S E R V I C E N O T E

Agilent E4268A 120Hz/1kHz Capacitance Meter

Serial Numbers: JP1KF00101 / JP1KF00363

Figure 1. AC Line Connector

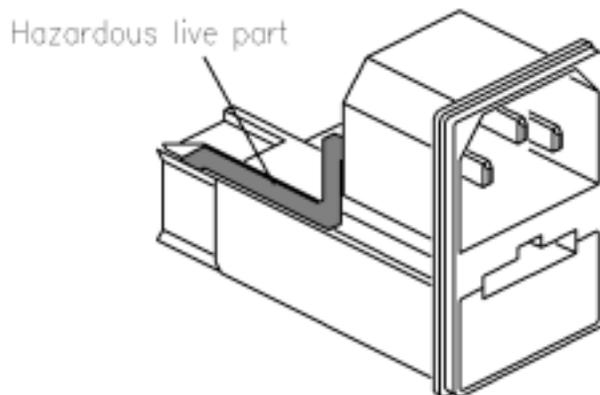
The AC inlet (P/N 1252-6951) has the potential to slip out of the instrument's rear panel slot if the AC power cord is forcefully pulled in a diagonal direction. When this happens, an exposed connection on the AC inlet module may touch the rear panel of the instrument and cause an electrical short if the AC power cord is still connected to the AC power outlet. See Figure 1.

- Remove the AC power cable from the AC power outlet and the product.
- Remove the top, bottom, and side covers.
- Seal the hot line terminal on the AC inlet with silicon paste (P/N 5183-4112).
- Reinforce the connection between the AC inlet and the rear panel with silicon paste.
- Perform Self Test to verify instrument operation.

Figure 2. Repair Completed Label

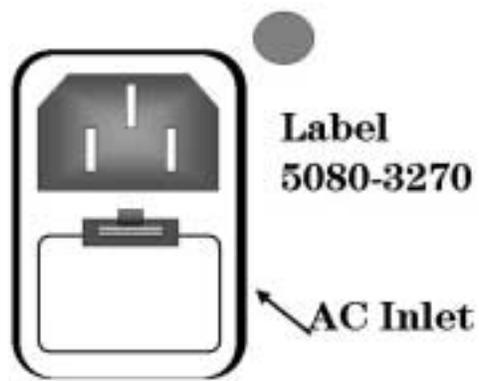
After completing the above instructions, stick the label (P/N 5080-3270) next to the AC Inlet on the rear panel as a mark that this repair has been completed. See Figure 2.
